SECTION 00 91 13.01 - ADDENDUM #1

The following provisions replace, revise, and/or add to the drawings and specifications titled "Howell Community Park: Site Improvements" dated "June 21, 2016. The contractor shall acknowledge said provisions by recognizing receipt of this Addendum on page I of the Louisiana Uniform Public Work Bid Form.

DRAWN	JAB
CHECKED	SMH
ISSUED DATE	6-21-2016
ISSUED FOR	BID
PROJECT NO.	16-111
FILE	16-111 C-0 Cover Sheet
SHEET	TS-1.0

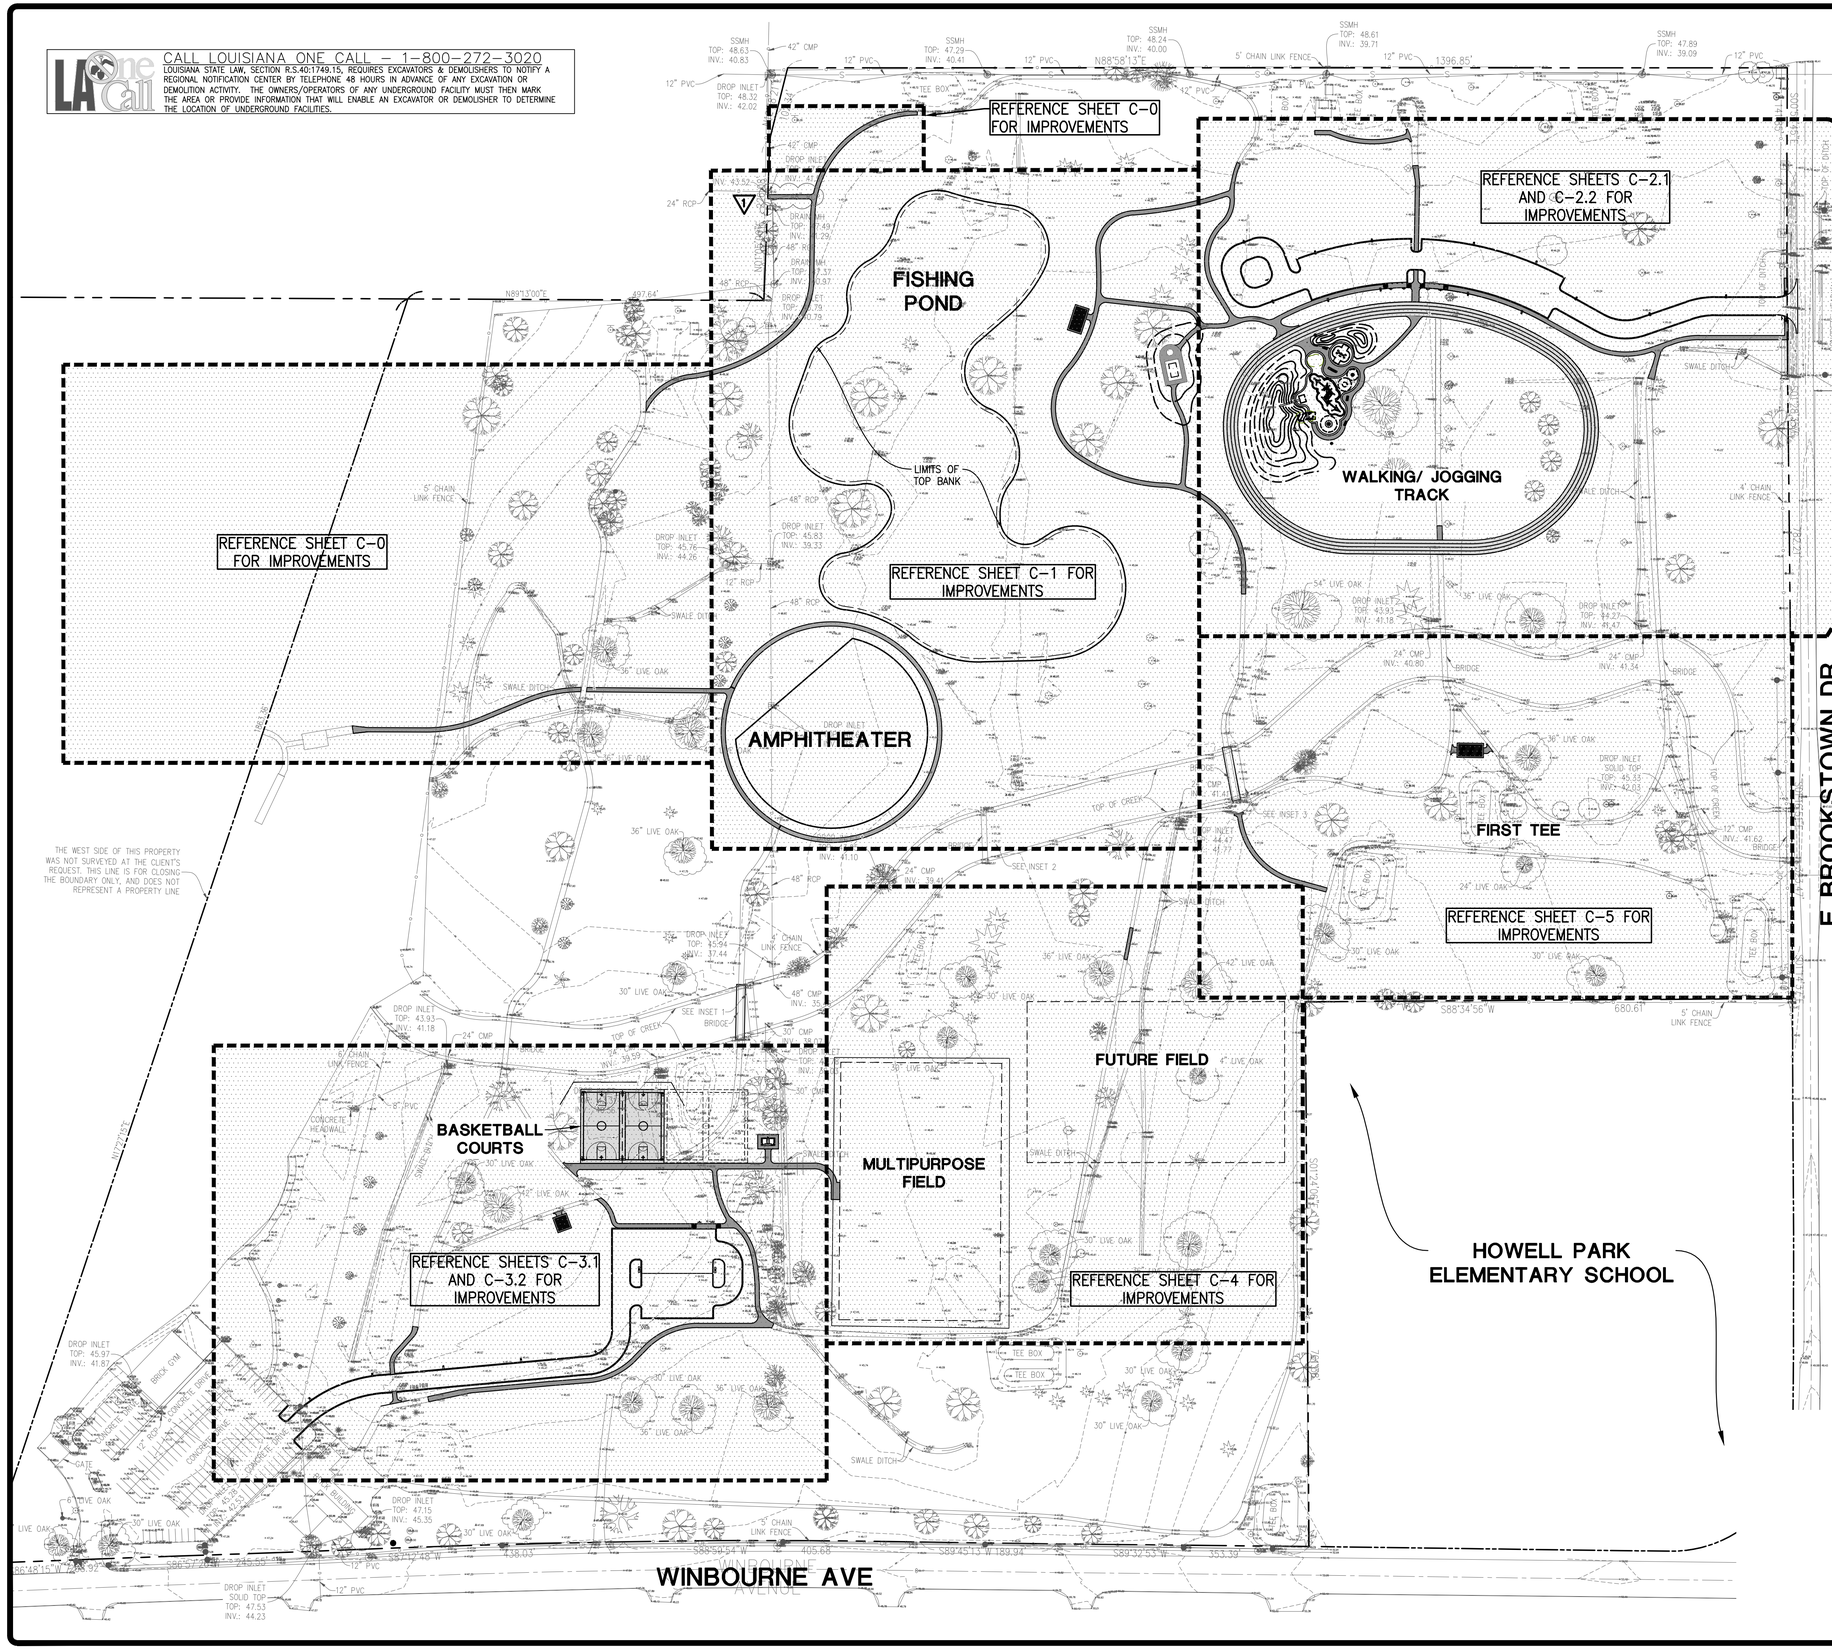
1. TS-1.0 Title Sheet
    a. Changed "TS-2.0 Overall Layout Sheet" to "TS-2.0 Overall Layout Plan".
    b. Changed "C-0 Site Plan" to "C-0 Improvements Plan".
    c. Corrected spelling of "Utility" in sheet name for sheets C-2.2 & C-3.2.

DRAWN	JAB
CHECKED	SMH
ISSUED DATE	6-21-2016
ISSUED FOR	BID
PROJECT NO.	16-111
FILE	16-111 C-1 Improvements Plan
SHEET	TS-2.0

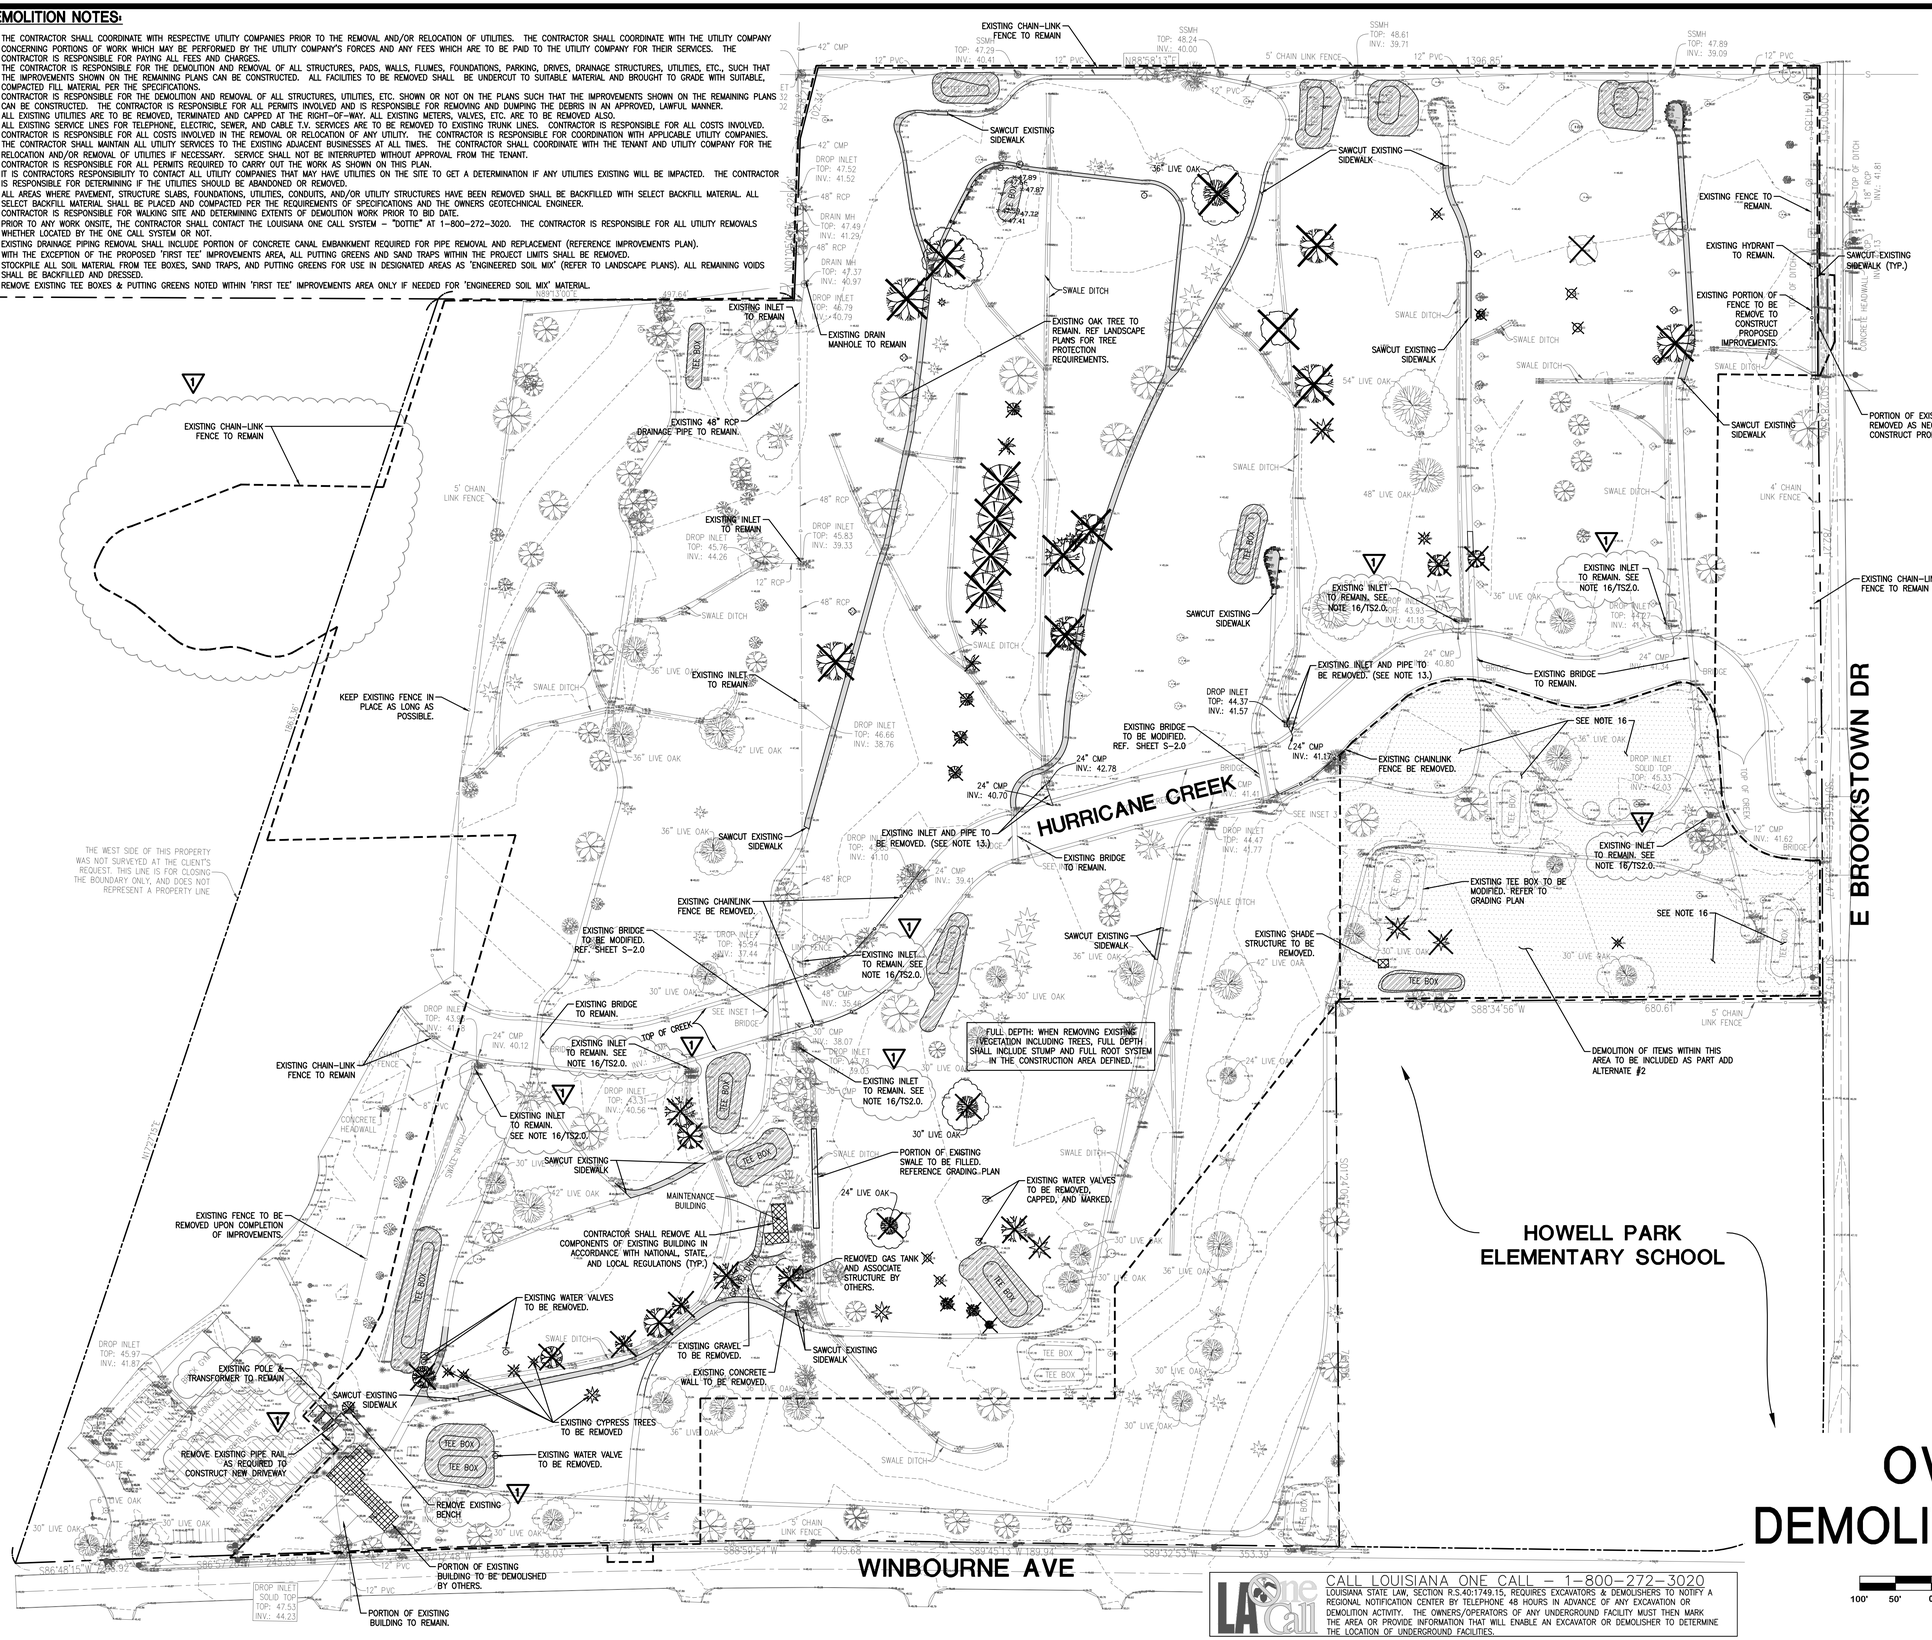
2. TS-2.0 Overall Layout Plan
    a. Relocated sidewalk connection to adjacent neighborhood.
    b. Added "Drainage" to "Pipe Notes".
    c. Added "or approved equal" to note 1.3 under "Drainage Pipe Notes".
    d. Removed legend.
    e. Revised Site Plan Note 11.
    f. Added Site Plan Note 17.

DRAWN	JAB
CHECKED	SMH
ISSUED DATE	6-21-2016
ISSUED FOR	BID
PROJECT NO.	16-111
FILE	16-111 C-1 Improvements Plan
SHEET	C-2.1

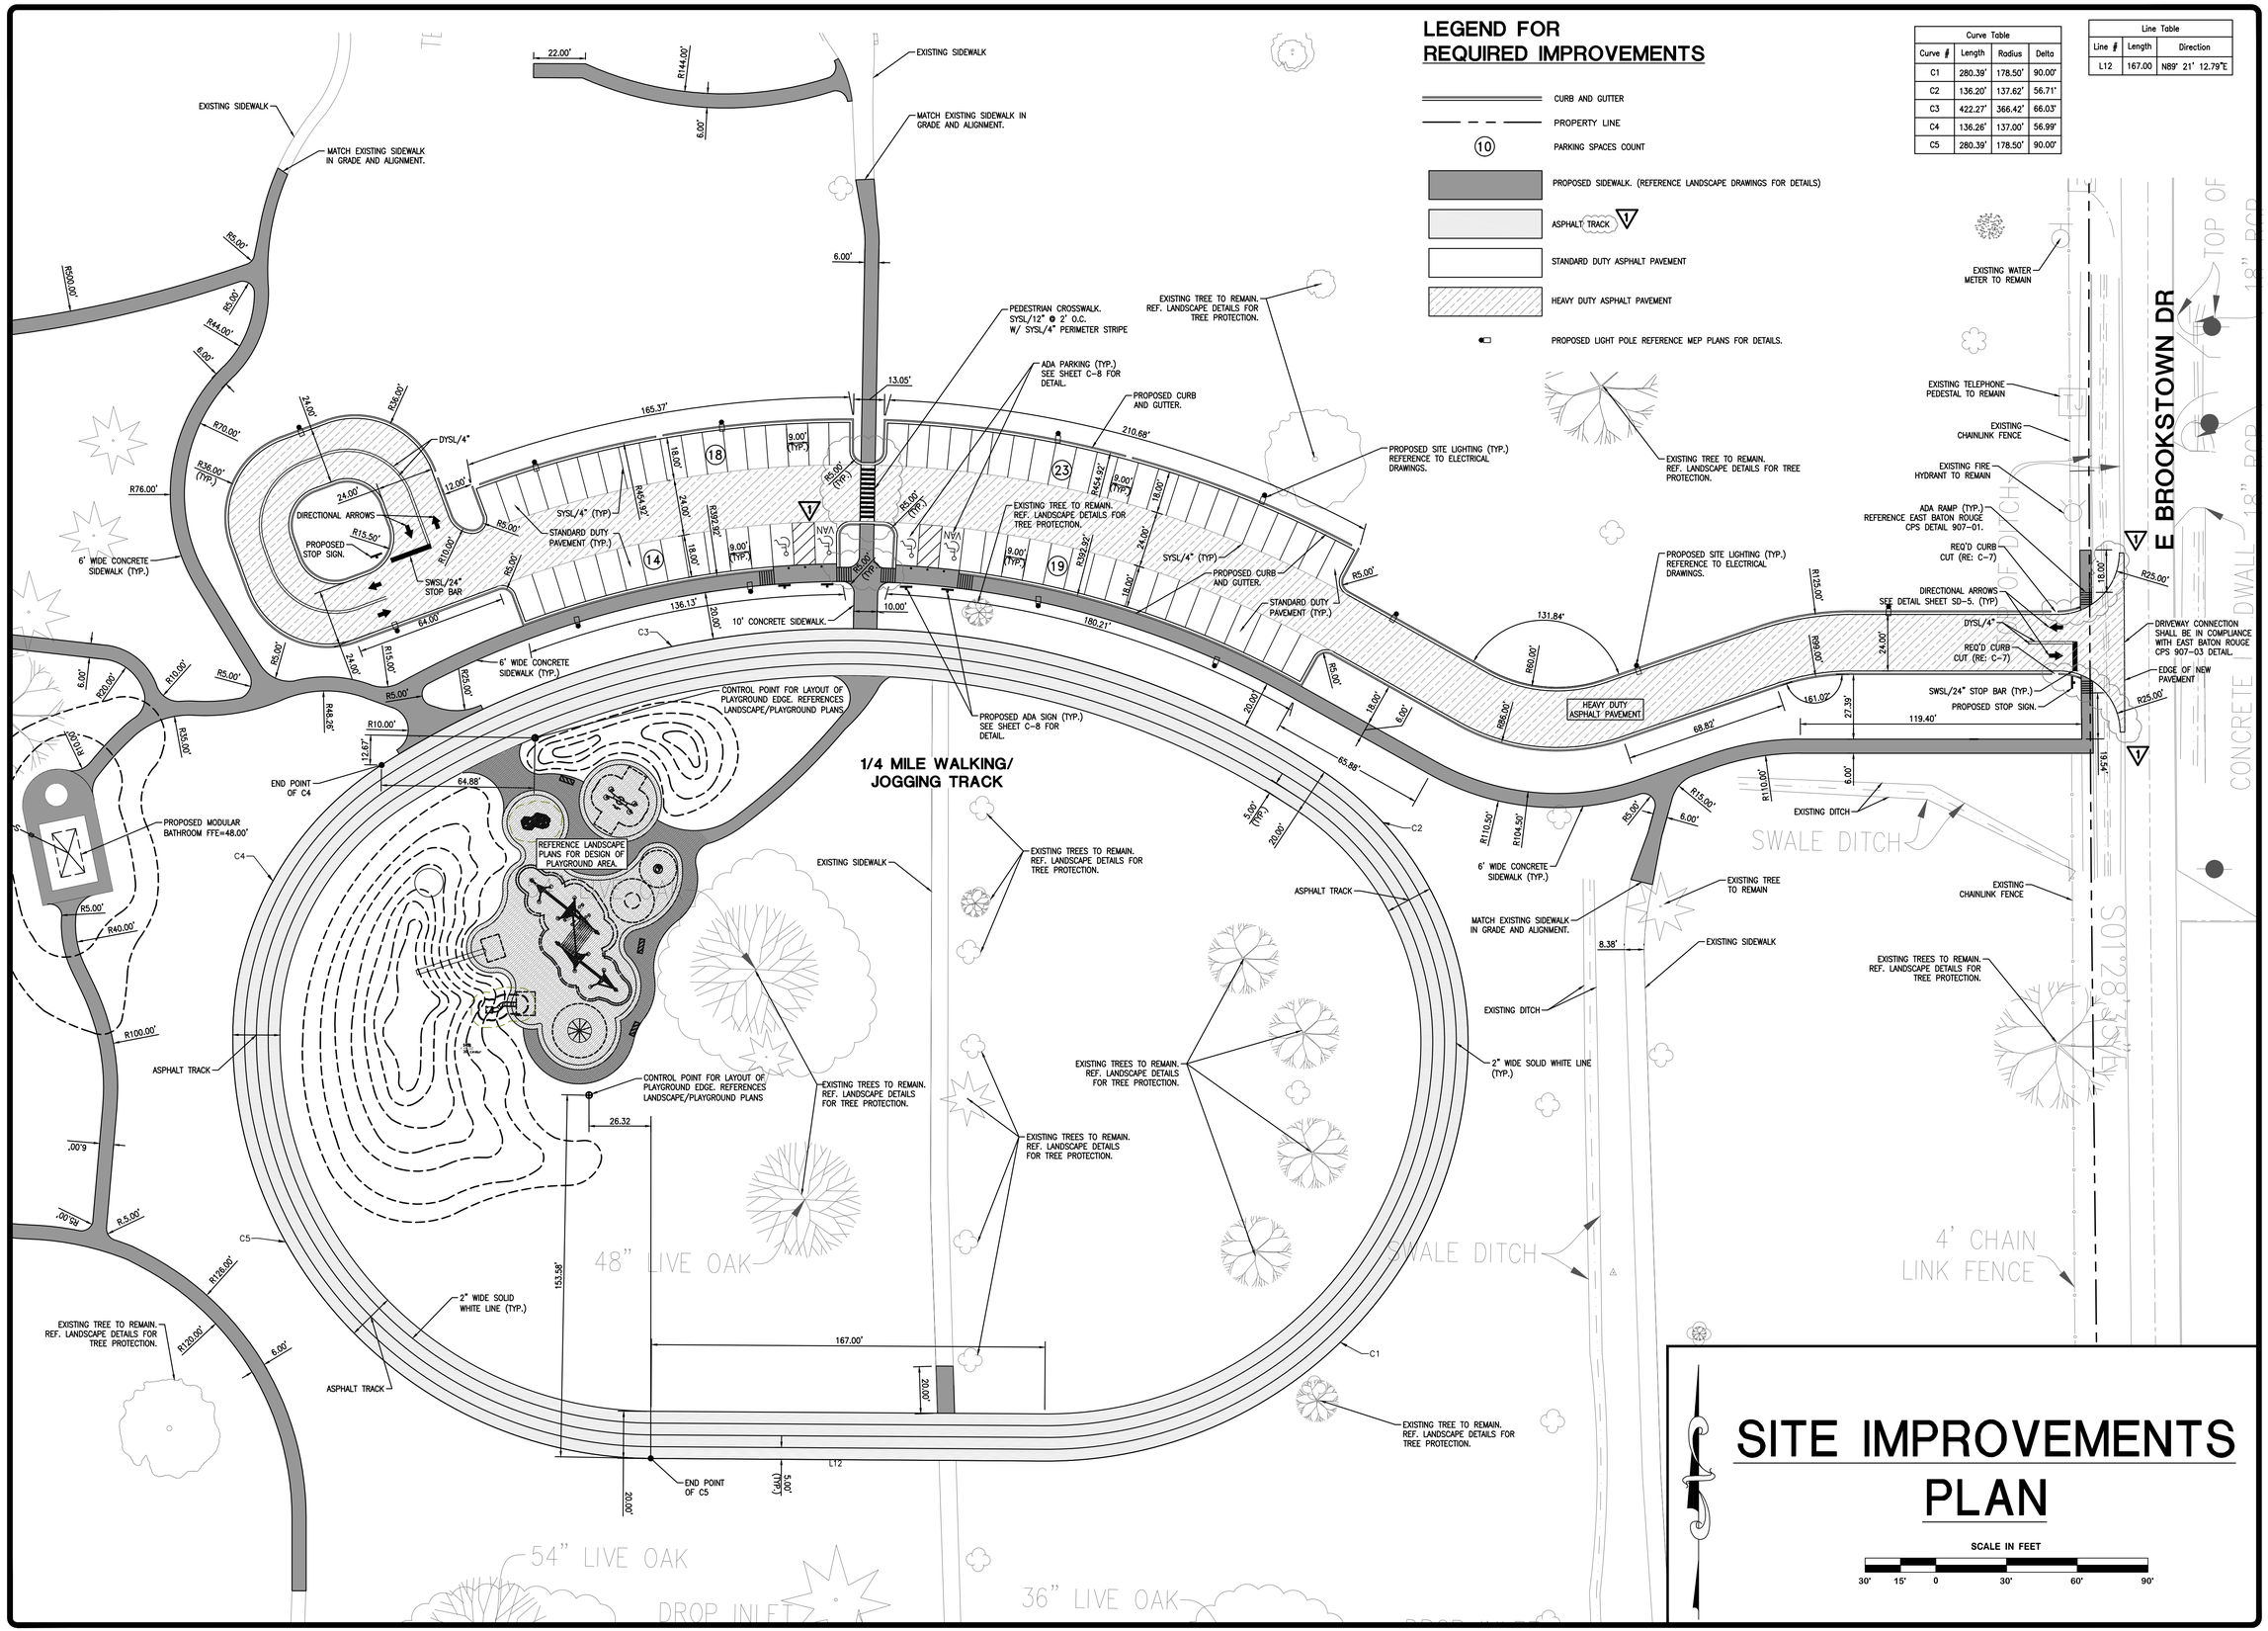
8. C-2.1 Site Improvements Plan
    a. Removed curbs along a portion of the entry drive along E Brookstown Rd (two locations).
    b. Added curb cuts behind entry drive (two locations).
    c. Removed required curb ramps at parking island (two locations).
    d. Added curb ramps behind parking island (two locations).
    e. Revised “Asphalt Court” to “Asphalt Track” in legend.
